Surface Water Assessment Pit 8 Extension Modification Wilpinjong Coal Mine Wilpinjong Coal Pty Ltd 8 August 2025 1052-15-D4 - Comments

WCPL is seeking to modify Development Consent (SSD-6764) to facilitate an extension of the existing Pit 8 (the *Pit 8 Extension*) within Exploration Licence (EL) 9399 and development of associated supporting infrastructure and facilities (the Modification).

The current report has been written to try and address the questions raised by the Wollar Progress Association. Sections 1-6 of this report address the specific information requests from the Wollar Progress Association; while Sections 7-12 provide supporting evidence for these conclusions. References cited are included in Section 13.

Figure 14. Flows in Wilpinjong Creek. Source: WRM 2025.

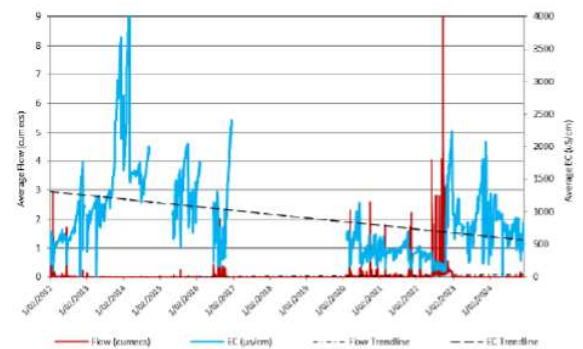
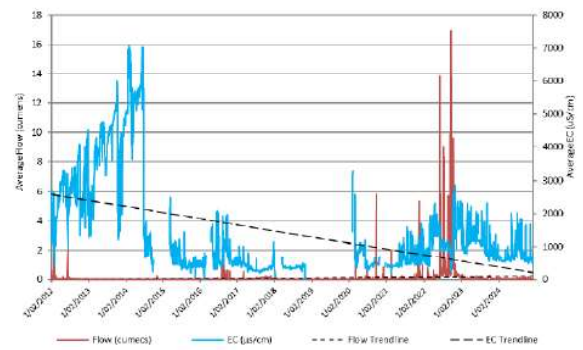
It is difficult to discern actual flows in Wilpinjong Creek in more recent times given the scaling used by WRM (2025) in their flow hydrographs (see Figure 14 below). It is additionally noted that they do not illustrate flow records prior to 2012 (which would include at least some baseline flow data for Wilpinjong Creek prior to mining commencing). Moreover, there has been no investigation of the

potential impacts of Wilpinjong mining on flows, especially at the gauging site WILSGD which now consistently receives ~4.5 ML/day of water from the RO Plant.

Figure 15. Modelled (left) and measured/gauged flows (right) in Wilpinjong Creek. Source: WRM 2025 (left) and WRM 2015 (right).

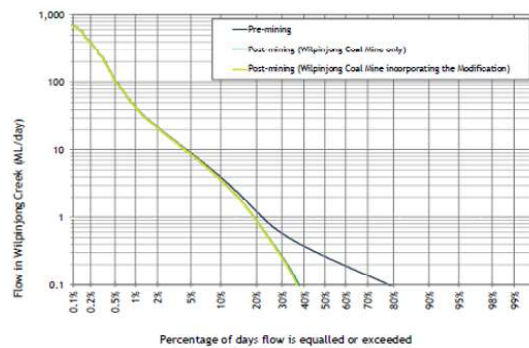
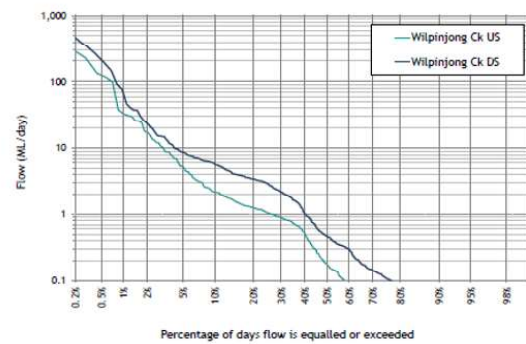
The presentation of flow exceedance curves for Wilpinjong Creek in WRM (2025) are contrasted with the flow exceedance curve provided in WRM (2015) - see Figure 15. It appears that the data presented in WRM (2025) is primarily modelled data as opposed to measured/gauged flow data⁵¹.

Figure 26. GDE Atlas mapping in the vicinity of the Pit 8 Extension area. Source: SLR 2025.

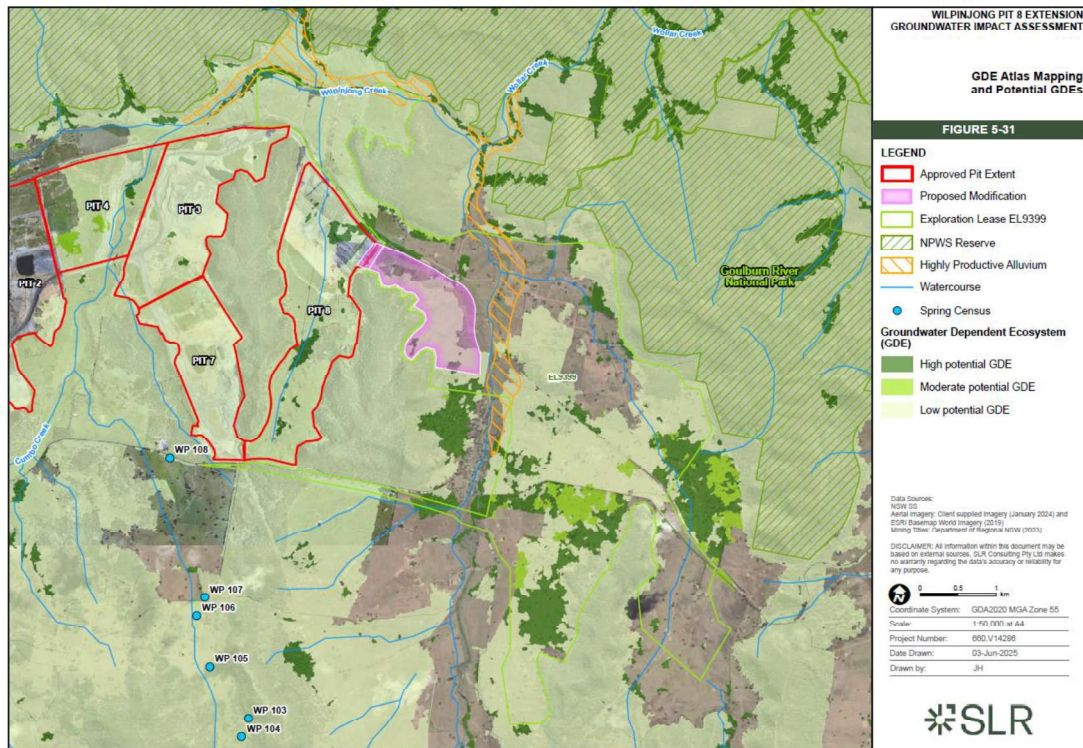
SLR (2025)⁸³ provided a figure that showed GDE Atlas mapping in the vicinity of the Pit 8 Extension area (see Figure 26). The figure shows many areas in valley headwaters, along drainage lines and adjacent to watercourses are mapped as 'high potential terrestrial GDEs'. There are also isolated vegetation communities across the area mapped as 'moderate potential terrestrial GDEs', while 'moderate potential aquatic GDEs' are also mapped along the Goulburn River north-east of Wilpinjong Coal Mine. A more detailed figure showing GDE's and Predicted Maximum Incremental Water Table Drawdown due to the Modification was provided in Section 8.3 Predicted Maximum Drawdowns (SLR 2025; see Figure 27). While the greatest drawdowns are associated with the pit itself, drawdowns of up to 10m are predicted adjacent to Wollar Creek and drawdowns of 1 to 5 m are predicted in the Wollar Creek *Highly Productive Alluvium*. These predictions do not bode well for the long-term integrity and natural flows for Wollar Creek.

Drawdowns of 1 to 2 m are also predicted for some *High potential GDE's*, with at least 3 of these *High potential GDE* areas located within Pit 8 itself. Given the potential dependence of these areas on groundwater, it is likely that many of these areas will no longer support GDE communities. Notably there is no current monitoring in place in the overwhelming majority of these areas to verify the accuracy (or otherwise) of these drawdown predictions.

Figure 28. Comparison of modelled and predicted flows in Wilpinjong Creek. Source: Wilpinjong Coal 2009 Annual Review (above); Wilpinjong Coal 2010 Annual Review (below)

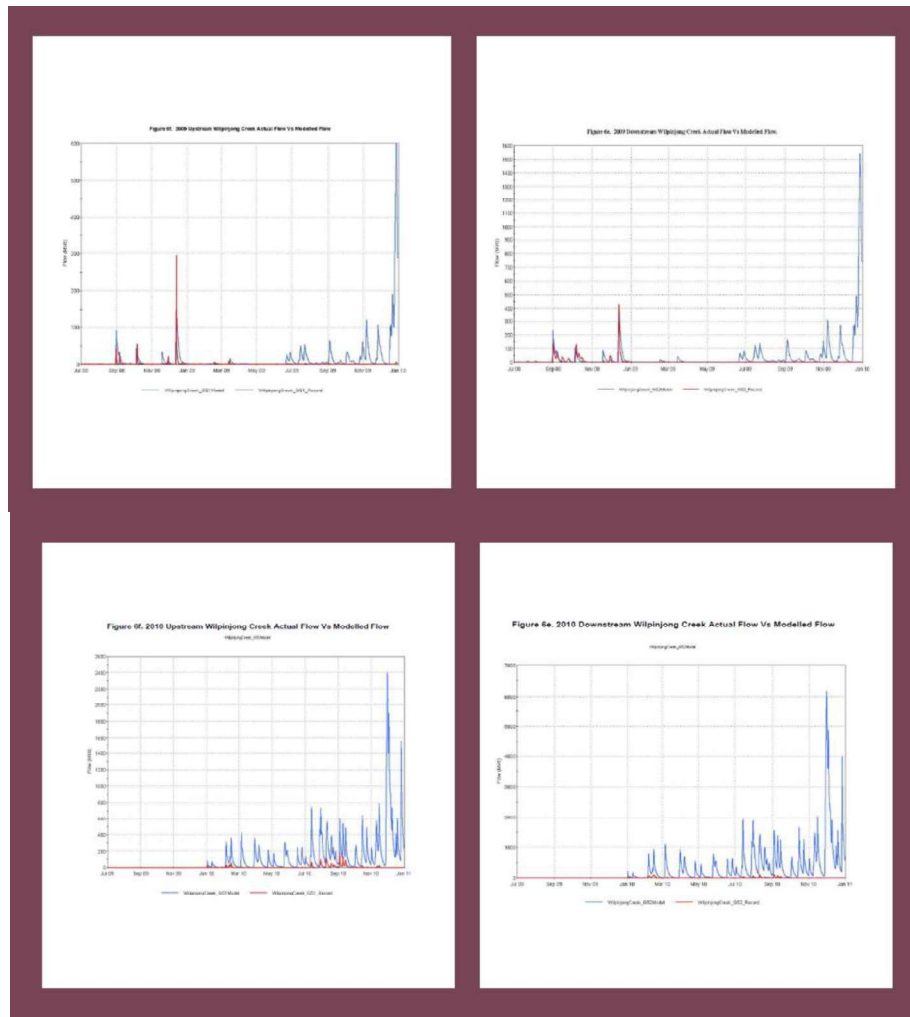
For the original EA, Gilbert and Associates (2005) developed an AWBM model to try and predict flows in Wilpinjong and Cumbo Creeks. A comparison of modelled and predicted flows in Wilpinjong Creek was provided in the Wilpinjong Coal 2009 Annual Review (see Figure 28 below). Whilst the AWBM model was able to replicate the 2008 flows in Wilpinjong Creek, it provided a very poor prediction for the 2009 flows. In particular, the model predicted flows between 600 ML/day (upstream gauge) and 1500 ML/day (downstream gauge) in December 2009 when there was virtually no flow recorded at either gauge. Similar discrepancies were seen in the predicted and observed flows in 2010 (see Figure 28). Such discrepancies cast significant doubt on the validity and predictive value of the AWBM model itself.

Figure 31. Flow exceedance curve for Wilpinjong Creek at the upstream and downstream gauges (left) and modelled flow exceedance curve for Wilpinjong Creek (right). Source: WRM 2015.

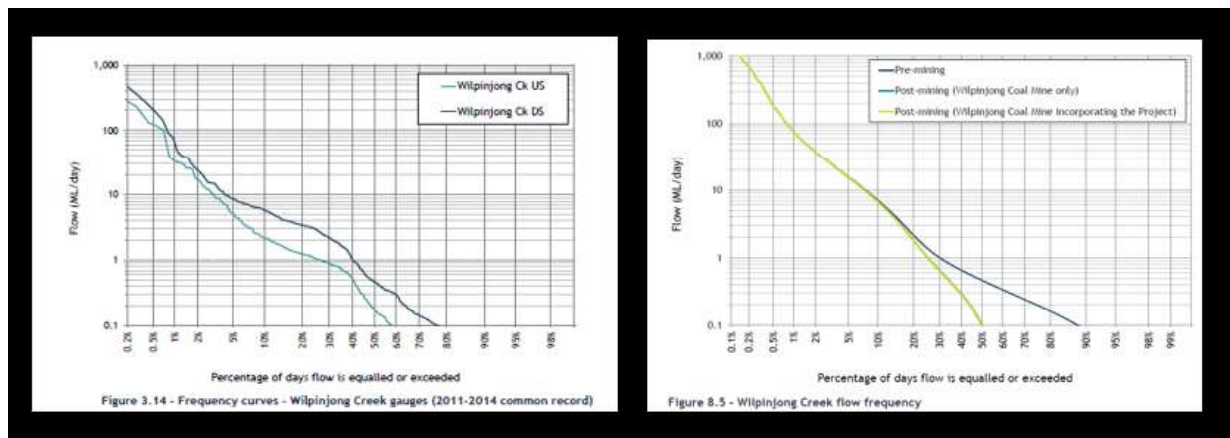
COMMENT: It is unclear exactly where in Wilpinjong Creek the modelled exceedance curve above was specifically related to. As can be seen from Figure 31, the modelled exceedance curve is not a good match to the observed exceedance curves for the Wilpinjong Creek upstream and downstream gauges. WRM (2015) did not provide any details on the AWBM model, and they did not provide any calibration graphs (observed versus predicted) for the AWBM model to assess the veracity of the predictions in relation to ‘real’ measured data. Given the significant increase in LDP24 discharges since the approval of the Wilpinjong Extension Project, the predictions from the AWBM model used by WRM (2015) appear to have been significantly underestimated. The Wilpinjong Extension Project has clearly had a *measurable incremental impact on flow in Wilpinjong Creek*.

Figure 32. Ulan Coal Seam Drawdown at the End of Mining (2033): Cumulative and Wilpinjong-specific effects. Source: Hydrosimulations (2015)

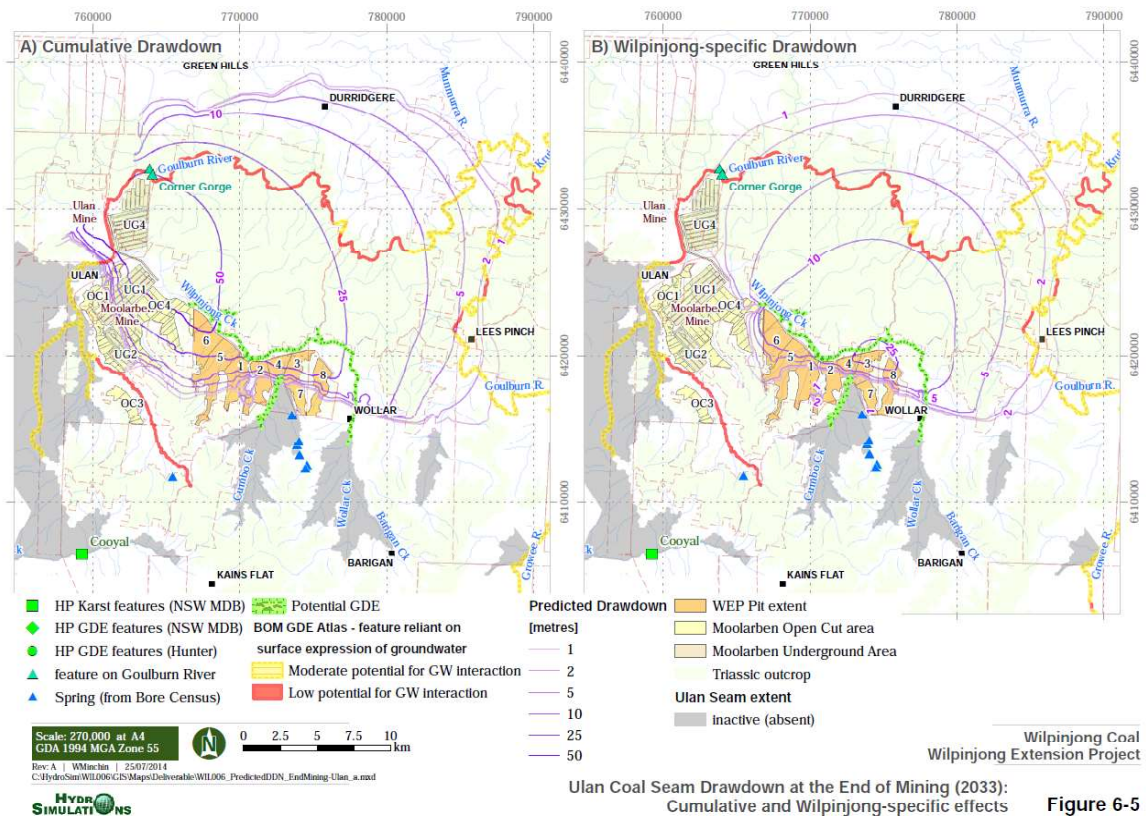
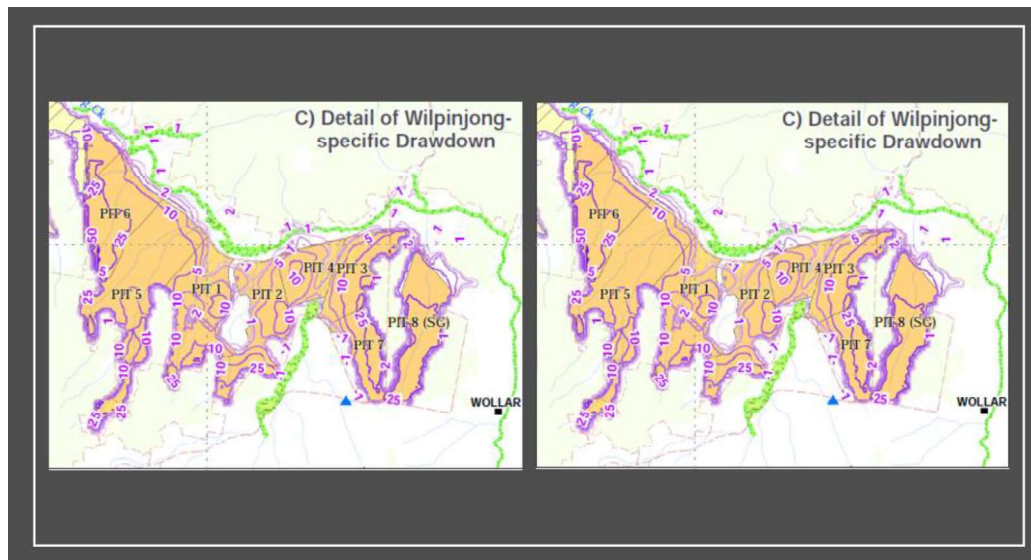
COMMENT: It is noted that Hydrosimulations (2015) groundwater model now predicted a zone of 25m drawdown directly under Wilpinjong Creek and a 10m drawdown in the Ulan Seam aquifer underneath Goulburn River National Park (Figure 32). This predicted cumulative drawdown within Goulburn River National Park was ~10 times the predicted drawdown provided by AGE (2005) – see above. A further 15-40m drawdown in the Ulan Seam aquifer underneath Goulburn River National

Park was predicted due to the cumulative action of Wilpinjong Mine together with Ulan and Moolarben mines. Closer to the Wilpinjong Mine Pits, Hydrosimulations (2015) predicted water table drawdown at the End of Mining (2033) ranging between 1m and 50m (see Figure 32). Strangely, exactly the same drawdown was predicted to persist until 2300 (see Figure 33).

Figure 34. Concordance between modelled and observed groundwater data for alluvial monitoring bores Gwa12 and Gwa14. Source: SLR (2024)

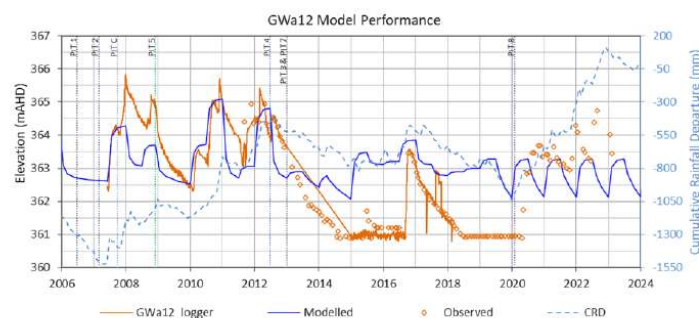
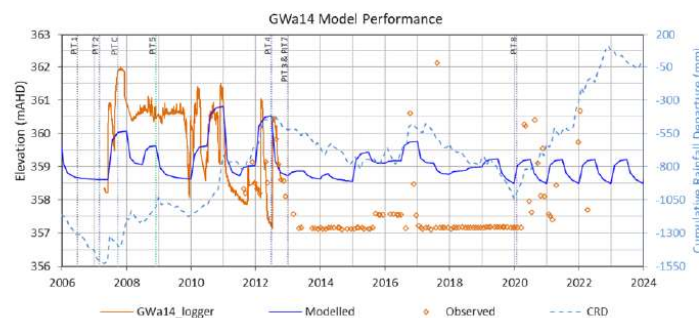
COMMENT: It is unclear whether the Hydrosimulations (2015) model is still being used, but SLR (2024)⁸⁴ provided a review of the concordance between modelled and observed groundwater data in their 2023 Groundwater Compliance Review. In many cases there was a very poor concordance between modelled and observed data. The model appears to do particularly poorly for the alluvial aquifers (for example, see Figure 34). In particular, the model appears unable to predict when the alluvial bores dry out completely. This lack of sensitivity and poor concordance between modelled and observed data casts significant doubt on the veracity of the groundwater model and its outputs.

Figure 35. Flow exceedance curve for Wilpinjong Creek at Cumbo Creek (left) and Wollar Creek at Wilpinjong Creek (right). Source: WRM 2025.

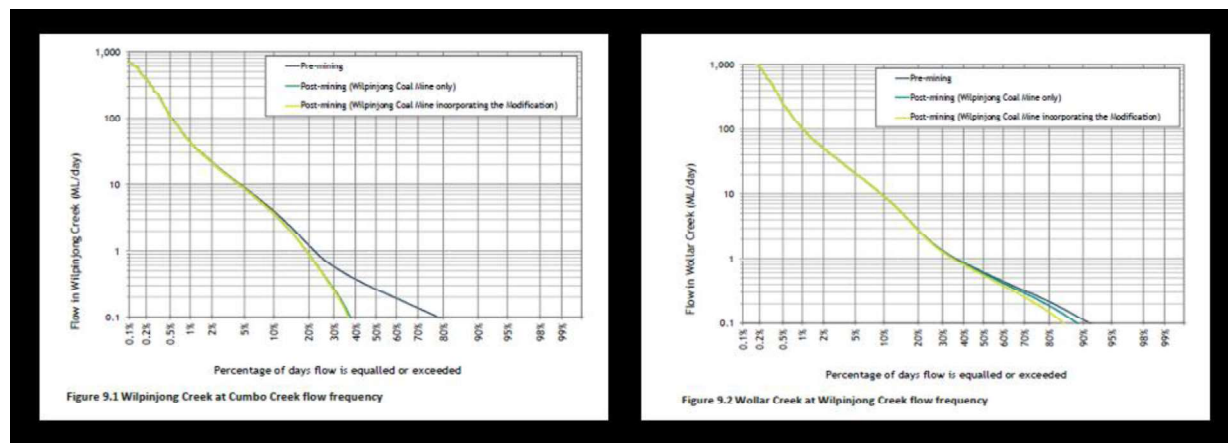
If the median flow (50th percentile) for Wilpinjong Creek at Cumbo Creek is estimated from WRM’s (2025) Figure 9.1, then for the pre-mining case, median flow would be approximately 0.3 ML/day. If the median flow (50th percentile) for Wollar Creek at Wilpinjong Creek is estimated from Figure 9.2, then for the pre-mining case, median flow would be approximately 0.5 ML/day. As identified in the *Stream Section* above, over the period of gauged records (1980 to 1997⁸⁵), median flows in Wollar Creek were 1.7 ML/day and the average flow was 9.01 ML/day. WRM’s (2025) modelling for Wollar Creek appears to significantly underestimate the typical flow in Wollar Creek.

Figure 36. Flow exceedance curve for gauged flows in Wilpinjong Creek (left) and modelled flows for Wilpinjong Creek at Cumbo Creek (right). Sources: WRM 2015 (left) and WRM 2025 (right).

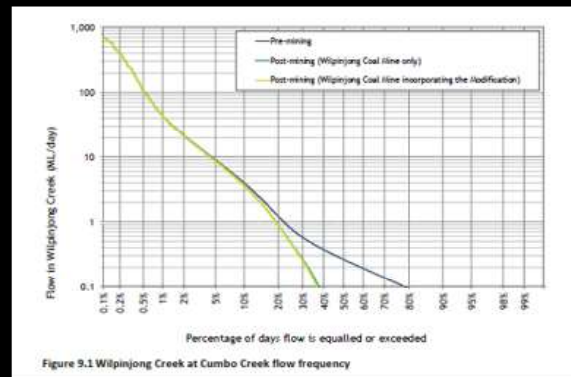
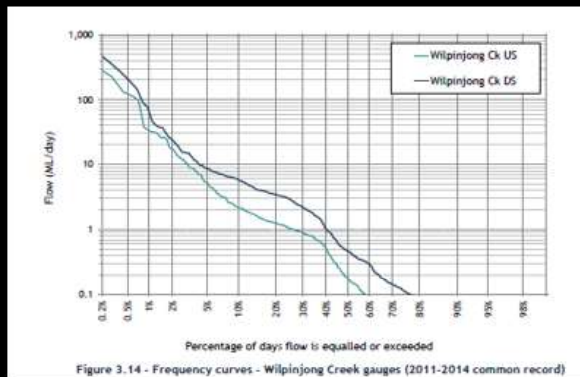
As can be seen from Figure 36 below, the modelled exceedance curve is not a good match to the observed exceedance curves for the Wilpinjong Creek upstream and downstream gauges provided by WRM (2015). It is also difficult to discern much of a difference between the WRM (2015) exceedance curve and the WRM (2025) exceedance curve for Wilpinjong Creek (see Figure 37). However, a close inspection of the two curves shows that the percentage of days that flow is equaled or exceeded is reduced by approximately 10% for the lower flow percentiles in the modelled 2025 data when compared to the modelled 2015 data. In particular, the 2025 “Pre-mining” exceedance curve is also approximately 10% lower than the 2015 “Pre-mining” exceedance curve for the lower flows (around 0.1 ML/day). Whilst it is possible that the 2015 and 2025 modelling used different points in Wilpinjong Creek to model flow exceedance, neither model appears to capture the reality of what has been happening in Wilpinjong Creek very well.

Figure 38. Predicted Maximum Incremental Drawdown in Layer 7 (Ulan Seam) due to the Modification.
Source: SLR 2025

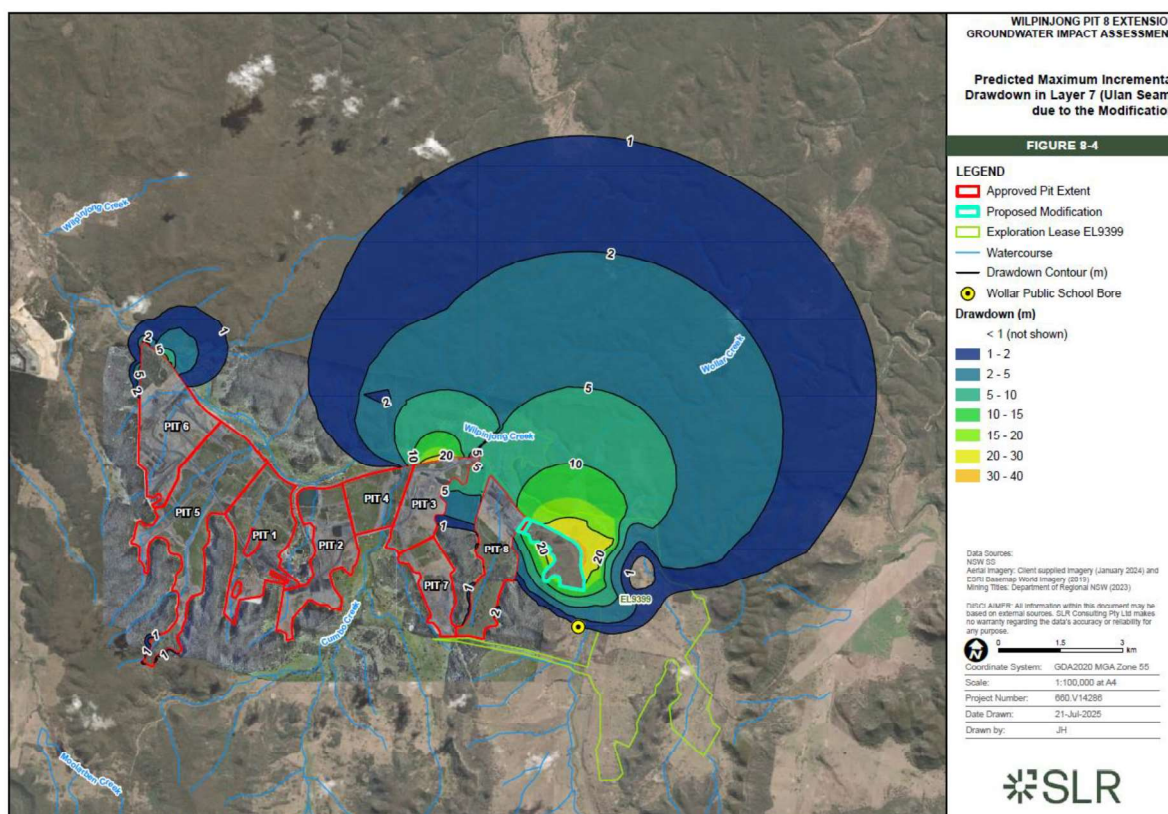
COMMENT: Figure 8-4 of SLR (2025) shows the Predicted Maximum Incremental Drawdown in Layer 7 (Ulan Seam) due to the Modification (see Figure 38 below). Here it is clear that drawdown of between 1m and 10m is predicted well inside Goulburn River National Park and underneath Wollar Creek. Figure 8-4 of SLR (2025) shows the Predicted Maximum Cumulative Drawdown in Ulan Seam (Layer 7) – see Figure 39 below. This figure identifies an even greater extent of drawdown with between 1m and 20m drawdown predicted inside even larger areas of Goulburn River National Park as well as underneath Wollar Creek. Given the demonstrated linkages between groundwater and surface water from past monitoring, there appears to be significant potential for impacts to aquifers not only in the vicinity of the Pit 8 Extension Modification, but also inside Goulburn River National Park.

Figure 40. Calibration Hydrographs for Gwa7, GWc4, Gwa32 and GWc32. Source: SLR 2025c

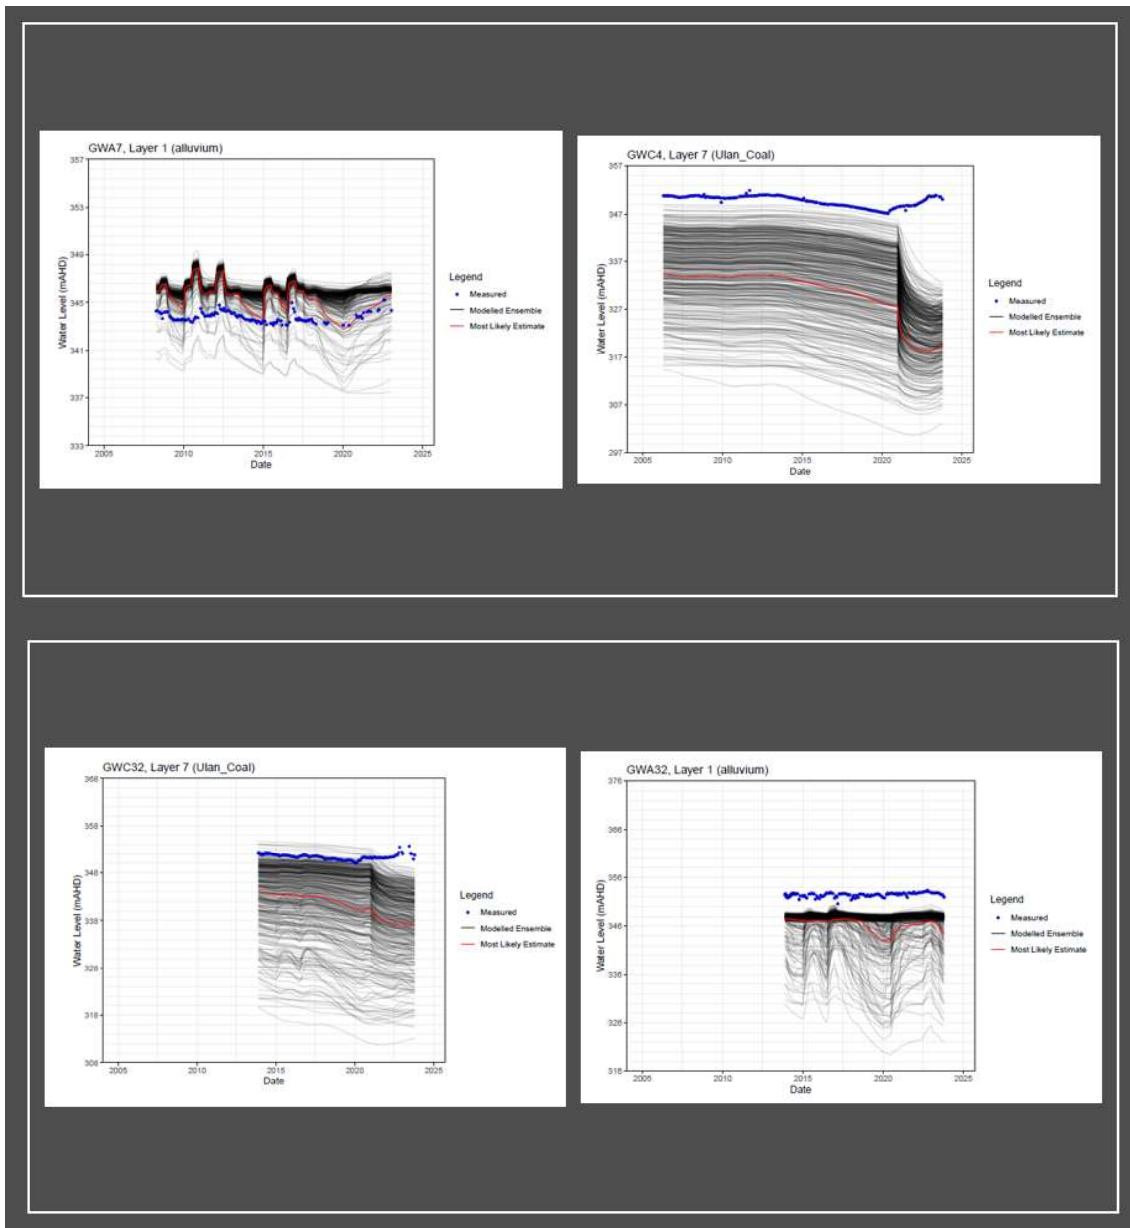
COMMENT: SLR (2025b)⁸⁷ also provided Calibration Hydrographs for the Pit 8 Extension Modification. Potentially the most important calibrations from an environmental perspective are those associated with Wollar Creek, especially given the potential for significant drawdown in the Wollar Creek *Highly Productive Alluvium* and in the vicinity of *High potential GDEs*. The most relevant bores in this area are Gwa7, GWc4, Gwa32 and GWc32. The Calibration Hydrographs for these bores are illustrated in Figure 40 below. It is clear that the current model provides quite a poor prediction for Gwa7, GWc4, Gwa32 and GWc32, with differences between measured and “most likely estimate” of the order of ~2m in the alluvium (Gwa7 and Gwa32) and 4-12m in the coal measures (GWc4 and GWc32).
